**RE: NEW BEDFORD-LOGAL LLC**  
DEP File No. SE 049-0702 - Response to Amended Order of Conditions (OOC) and Construction  
Review Comments-100 Duchaine Boulevard

**WET BASIN 1 REMEDIATION EXHIBIT PLAN**  
**LOGAL, LLC**  
100 DUCHAINE BOULEVARD  
NEW BEDFORD, MASSACHUSETTS

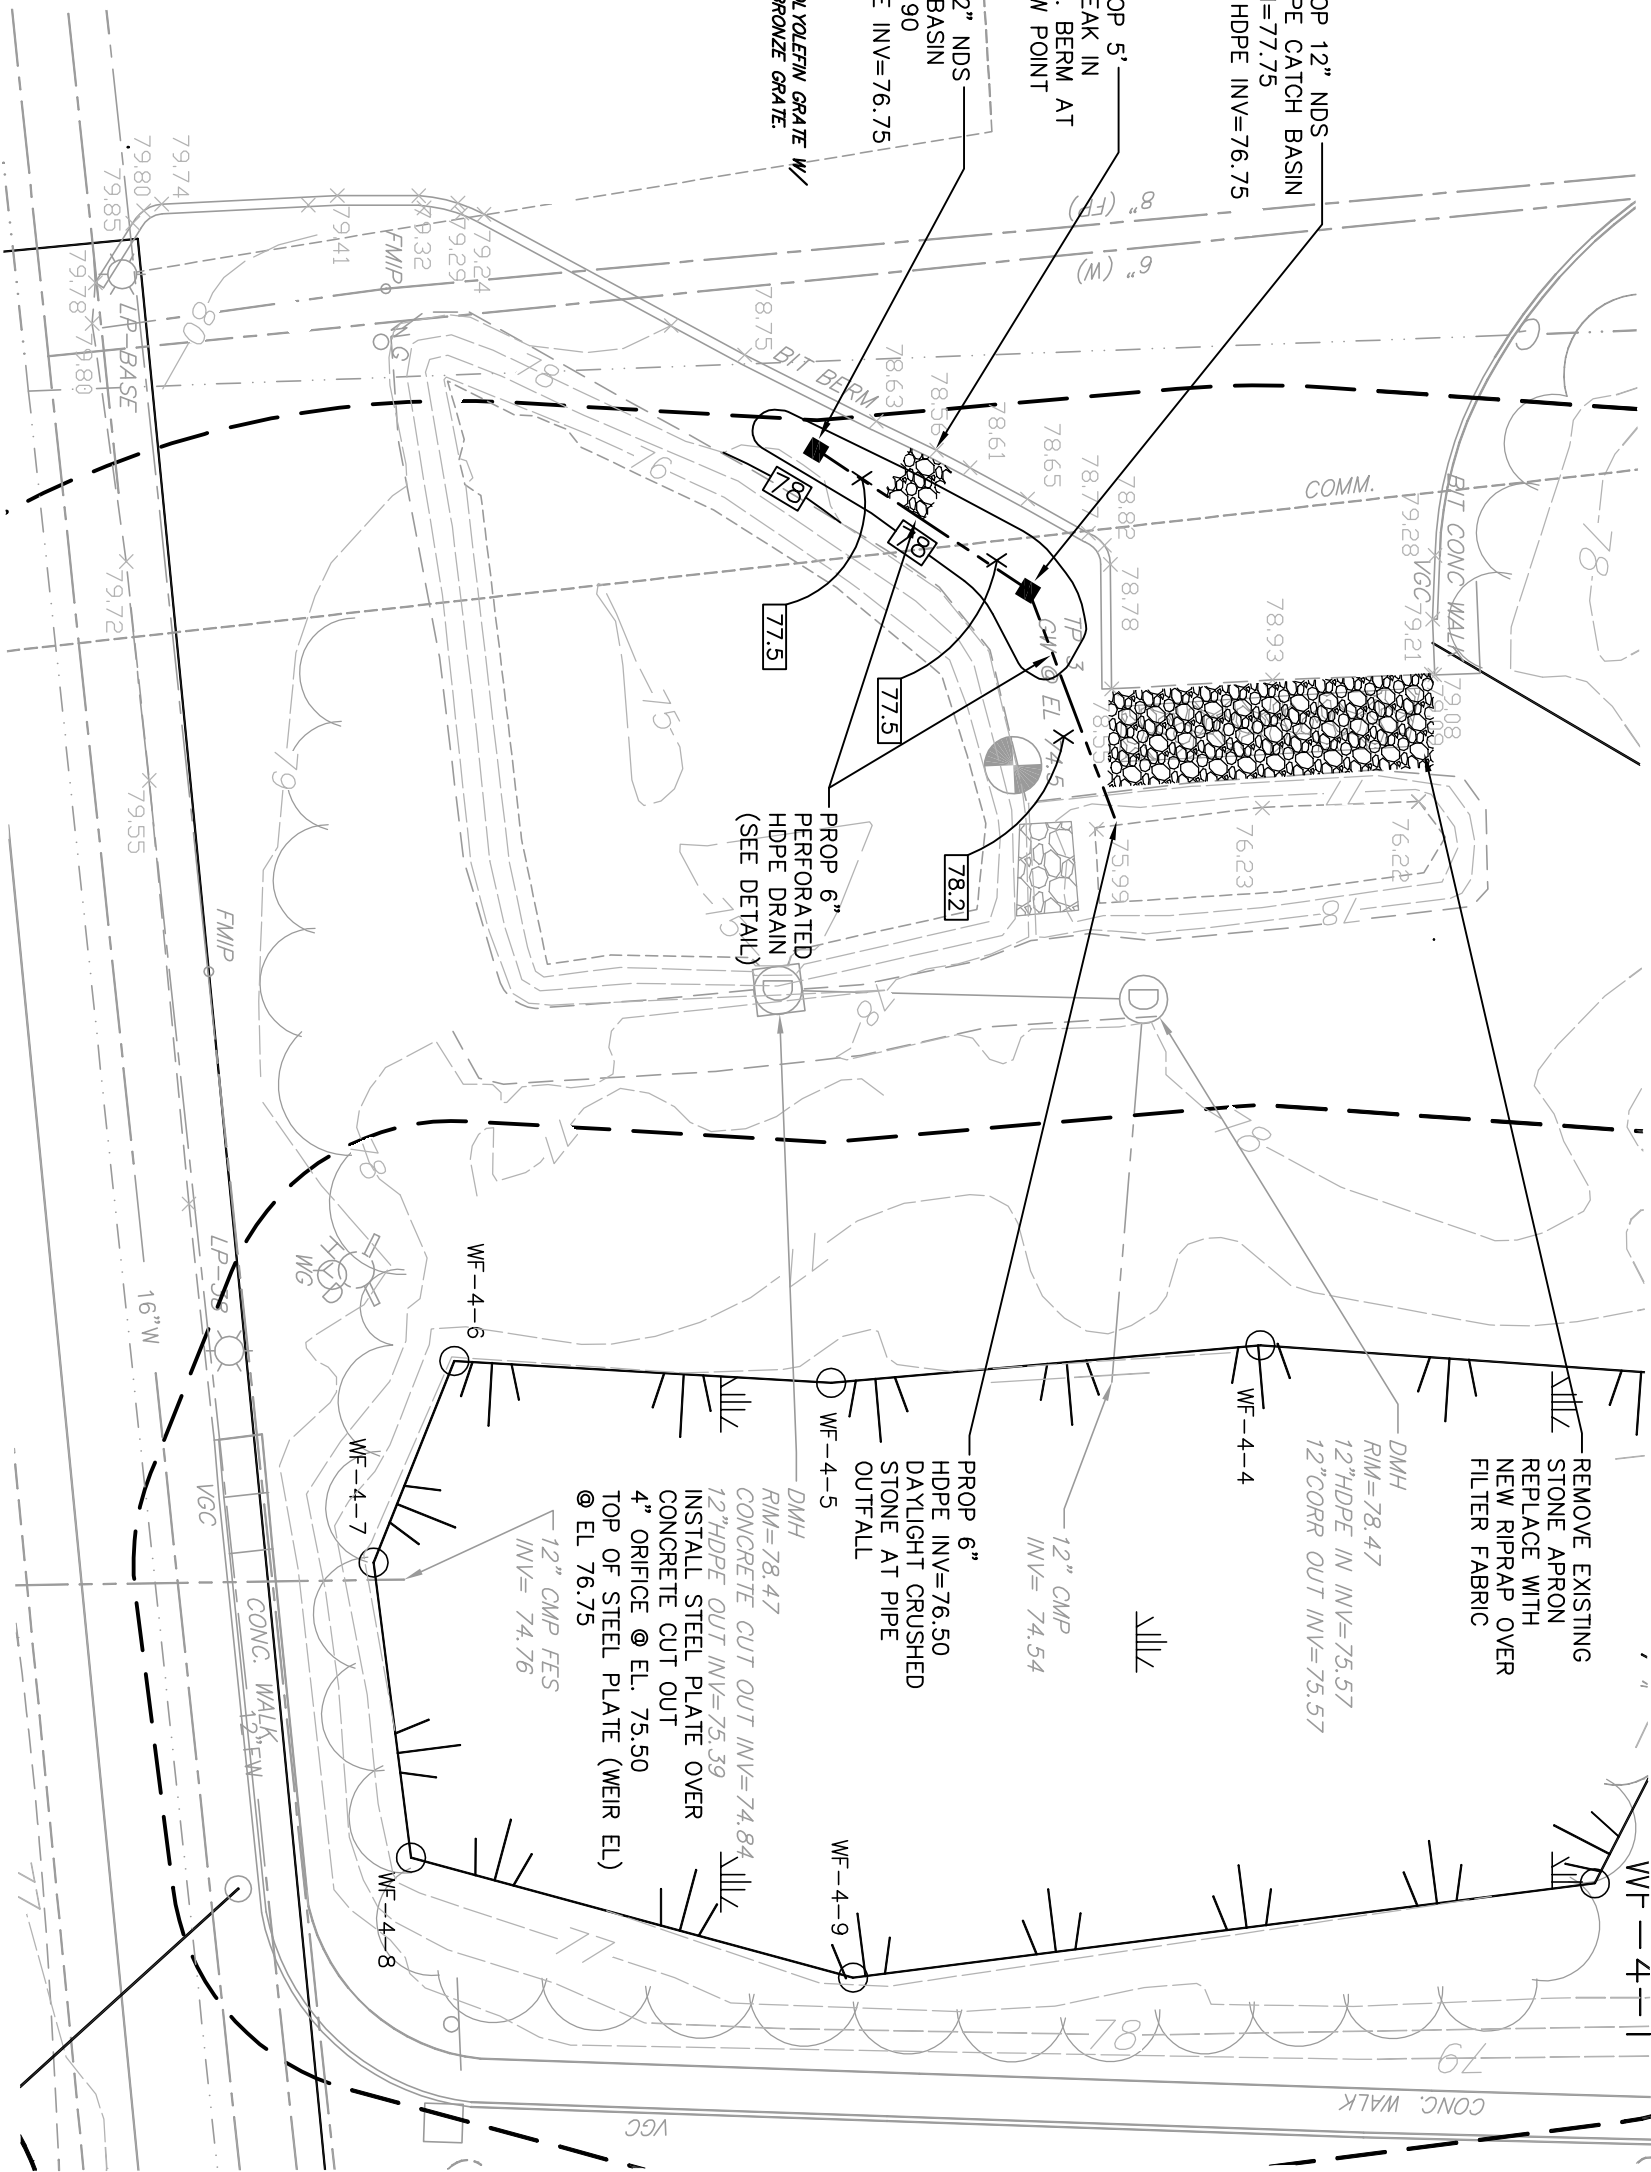
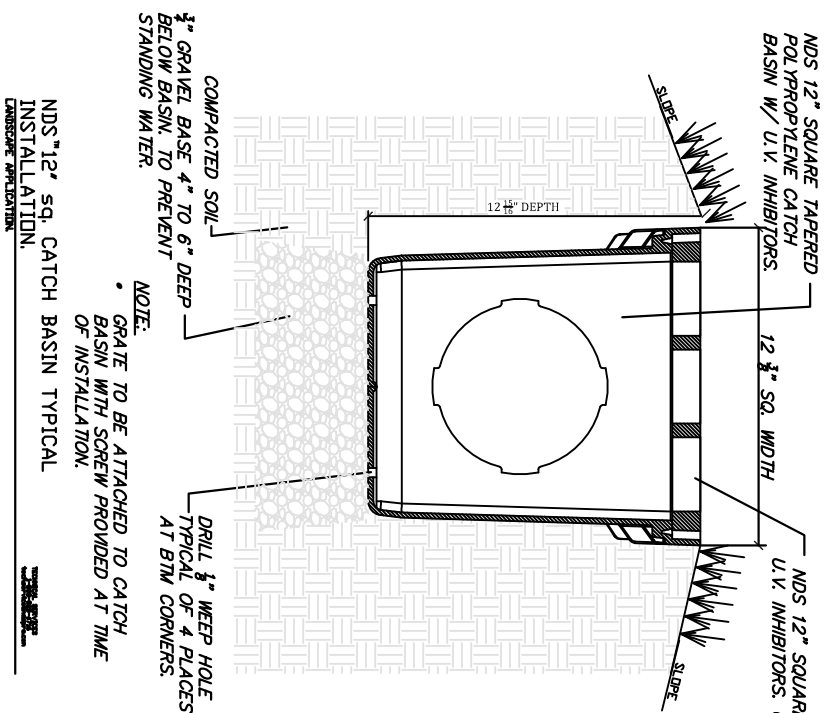
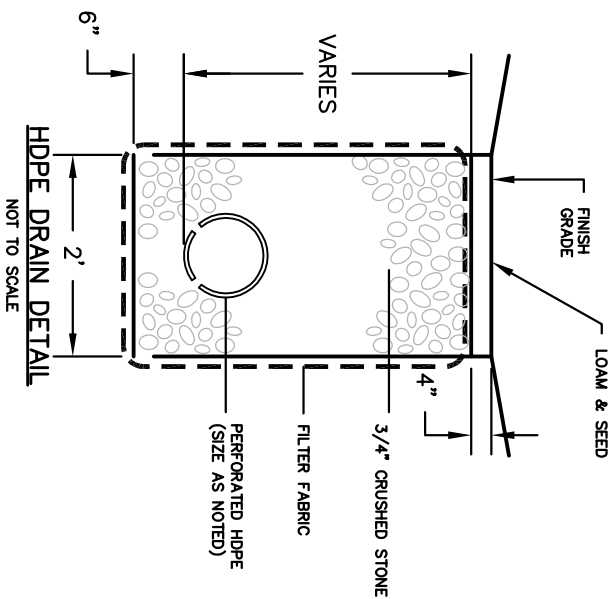
1. The parking area that was designed to sheet flow to the sediment forebay that is part of Wet Basin 1 was not graded properly. Instead of the parking area flowing directly to the sediment forebay, portions of the parking area flow towards a low point near the storage portion of the basin. During heavy storms, water collects in the low spot and then overtops the Cape Cod berm that was installed along the parking area before flowing directly into the storage area of the wet basin. The side slopes in this area of the wet basin have eroded. In some areas, this erosion is significant and has left deep channels in the side of the wet basin. The basin is not graded consistent with the approved plans. The plans show the side slopes to the basin be graded to the edge of the parking lot. However, there is a six to eight-foot flat area between the top of the side slopes to the basin and the edge of the parking lot.

2. Rich Riccio had submitted a plan depicting the extension of a rip-rap apron to collect stormwater that is overtopping the Cape Cod berm. During the site visit, additional options were discussed. It is important that stormwater that is generated by the parking lot be routed through the sediment forebay to insure that it receives adequate treatment in accordance with the Stormwater Management Guidelines. Therefore, if the parking lot is not regraded, a piped solution will be necessary to route this water to the forebay. Given the fact that there is some space between the edge of the parking lot and the top of the wet basin, there is an opportunity to create a depression or series of depressions that could collect the stormwater and route it directly to the sediment forebay. We discussed developing a plan that shows depressions along this flat area with field drains. The rim of the field drains should be set at an elevation that is higher than the bottom of the depressions but lower than the berm at the top of the storage portion of the wet basin. I recommended that as-built information be collected to perform this design. This design should be submitted to the Conservation Commission as part of the request for an Amended Order of Conditions.

7. The side slopes of the wet basin appear to be too steep. The owners' representative indicated that they do not mow them because they are too steep. The side slopes should be checked to see if they are at the proper slope. Any areas of the side slopes that have experienced significant erosion need to be repaired.

**Response: We have collected as-built information related to the area described above and have developed a revised design plan showing a series of two field drains set in a shallow depression within the flat area. These field drains will discharge via a perforated HDPE Pipe set in a stone trench to the existing sediment forebay.**

**Response: We have collected as-built data for wet basin 1 and this information is depicted on the attached updated Exhibit Plan to accompany the Request for Amended Order of Conditions. The owner has been repairing the side slopes as necessary and we will continue to monitor their**

condition and recommend additional solutions should erosion continue. The as-built data shows that wet basin 1 was constructed with steeper side slopes than recommended and less storage volume than originally proposed. We have reviewed the as-built hydrologic calculations of the basin with a slightly revised plate configuration on the outlet control structure and the wet basin will still function in accordance with the design plans (following installation of the steel plate) in meeting or reducing the rates of runoff to the subject Analysis Point. A revised comparison of the pre-development versus post development hydrologic calculations has been provided as an attachment to this response letter. The installation of the steel plate will occur prior to the submittal of a Request for Certificate of Compliance.

New RipRap Pad  
Wet Basin 1

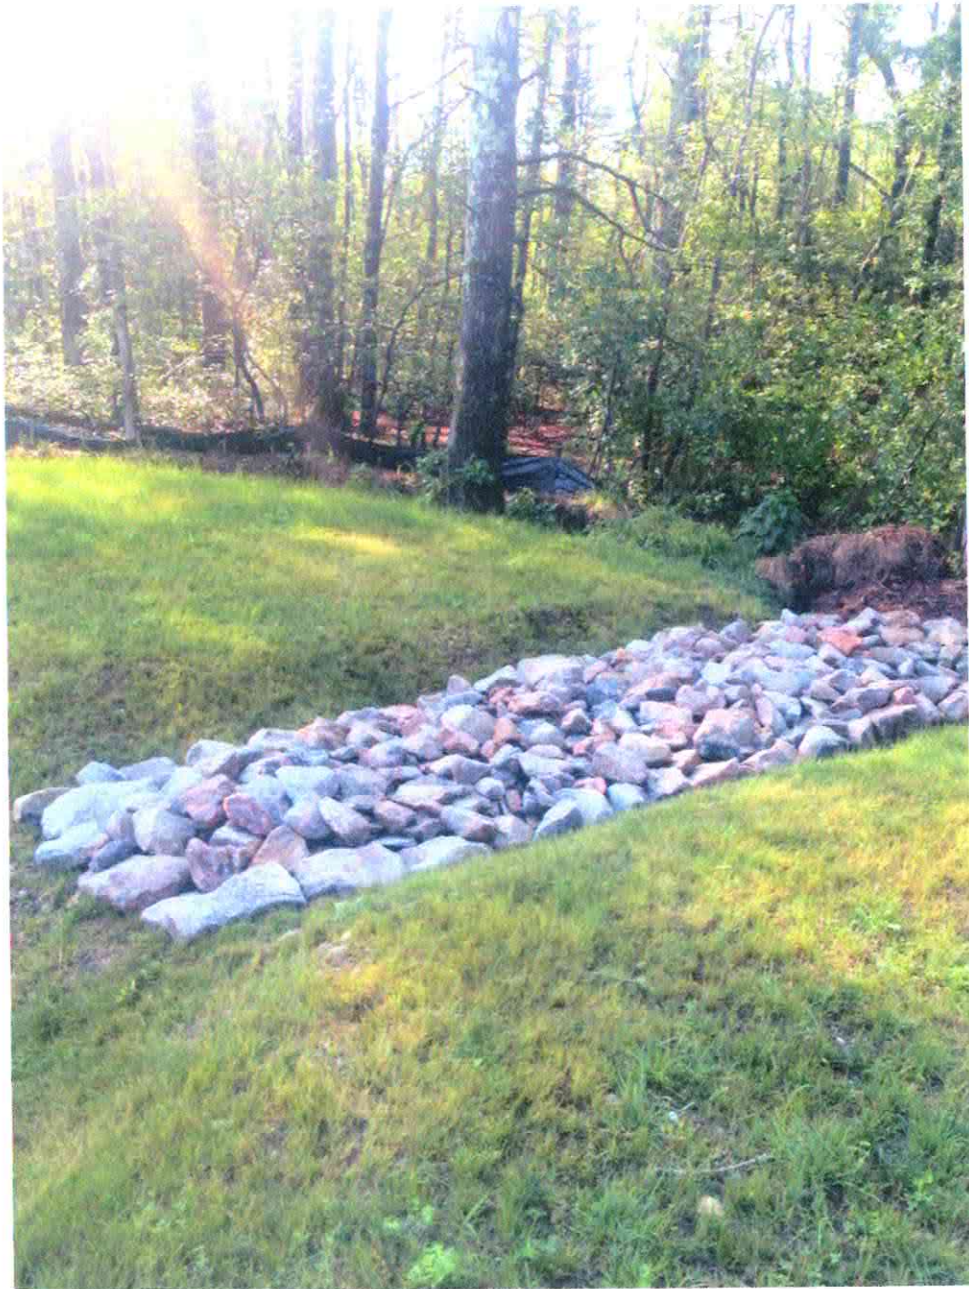
4. The rip rap pad that is located upstream of the sediment forebay is not working properly. The stone is too small and the pad has accumulated a significant amount of sediment. Stormwater simply runs over the top of the pad. Erosion of the side slopes has also begun. The design of the rip-rap pad needs to be re-evaluated and installed with stone that meets the specifications of the approved plans.

5. The edge of the bituminous parking area near the sediment forebay has eroded. This could be due to water running off the edge of the parking area or vehicles backing into this area and rolling off the edge of the bituminous. I recommended that a curb be installed flush with the pavement in this area to prevent the bituminous from eroding further. The owner agreed to do this along with the other improvements in this area.

**Response: The owner has already replaced the "riprap" pad located upstream of the sediment forebay with new riprap placed over a layer of filter fabric. Pictures of this work have been submitted to the Commission.**

**Response: In repairing the "riprap" pad referenced above, the owner has brought in larger stone and has "buted" the stone right up to the existing edge of pavement. We feel that with the larger stone right up against the edge of pavement, backing of trucks over the edge of the pavement will be minimized. Upon further review of this area during the installation of the new riprap, we do not feel installing the flush concrete curb is necessary at this time, but will continue to monitor this area for any future erosion. Please see attached pictures showing the installation of the riprap in this location.**
